**ERCOT Independent Review**  
**Centerpoint Energy/Texas New Mexico Power Alvin 345 kV Tie**  
**Project**  
**November 7, 2006**

# ERCOT Independent Review

## Centerpoint Energy/Texas New Mexico Power Alvin 345 kV Tie Project

**Figure 1: TNMP Bay Area Transmission System**

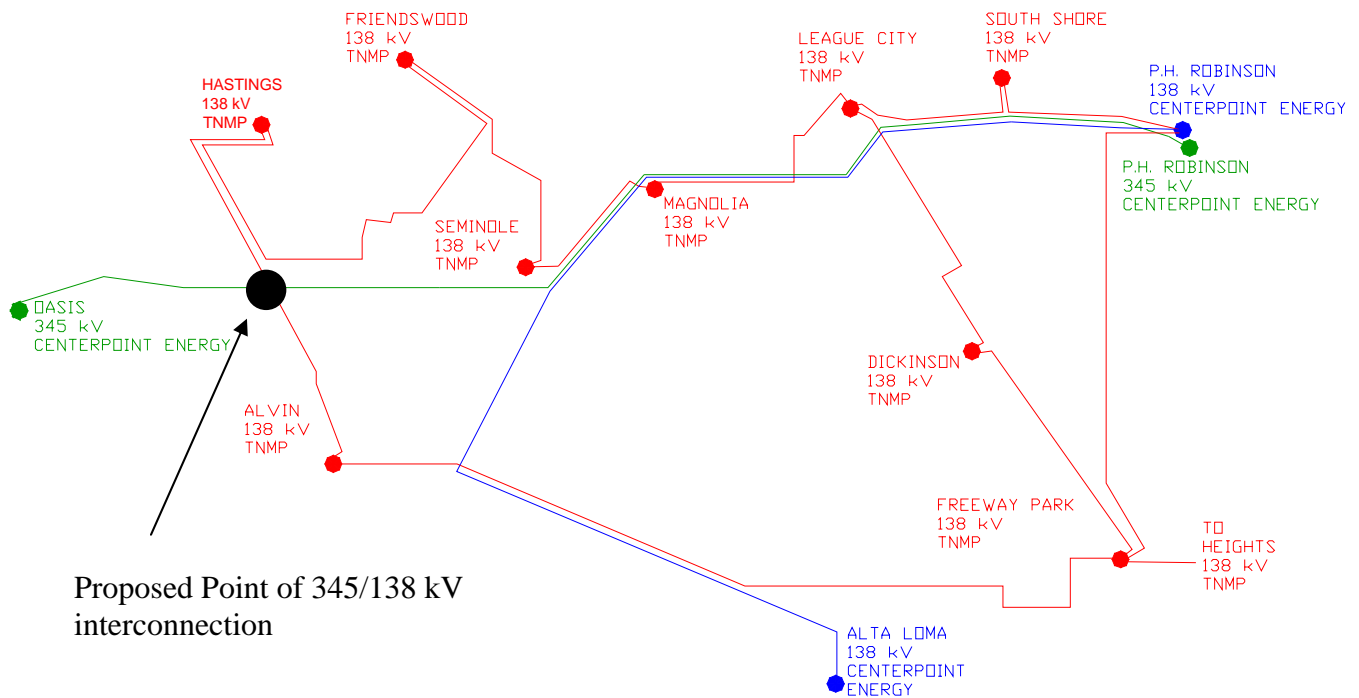
Centerpoint Energy (CNP) and Texas New Mexico Power (TNMP) submitted a project in July 2006 to solve reliability problems in TNMP's Bay Area Loop. This loop is shown in Figure 1 in red from PH Robinson to League City to Alvin to Freeway Park.

This project proposes to construct a new 345/138 kV station between the Hastings and Alvin 138 kV stations on the west side of the bay area loop. This new station will then be looped into the existing PH Robinson to Oasis 345 kV and Hastings to Alvin 138 kV circuits.
